Application Number	PT8TT134
Applicant Name	Tipperary County Council
Development Address	R445 Carraigeway birdhill Gortybrigane and Birdhill

Re: Part 8 – Proposed Birdhill Active Travel Scheme.

Figure 7-2: Existing / Relocated & Indicative Lighting Poles Locations at Proposed Scheme Area (Source: DeadSure Lighting App)

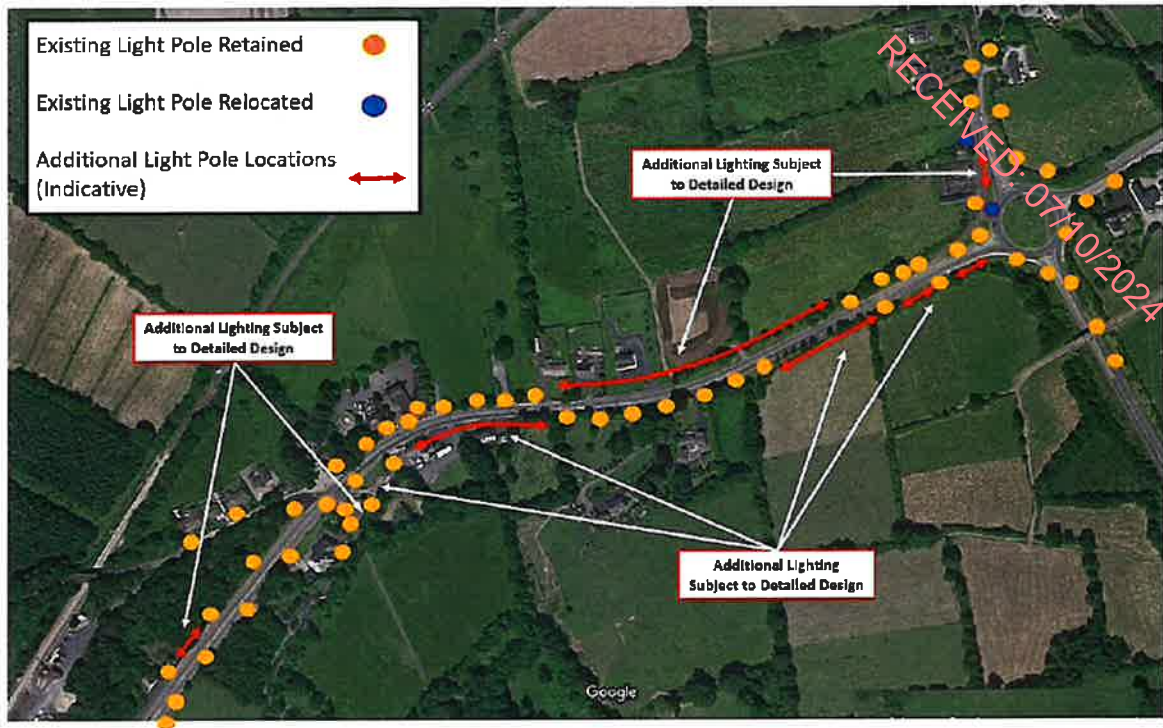
5. Public Lighting – The below figure illustrates potential additional lighting across the front of our property, subject to design. We request that any potential light poles should be located on the boundary lines between our property and neighbouring properties. We do not want any light poles located directly in front of our property.
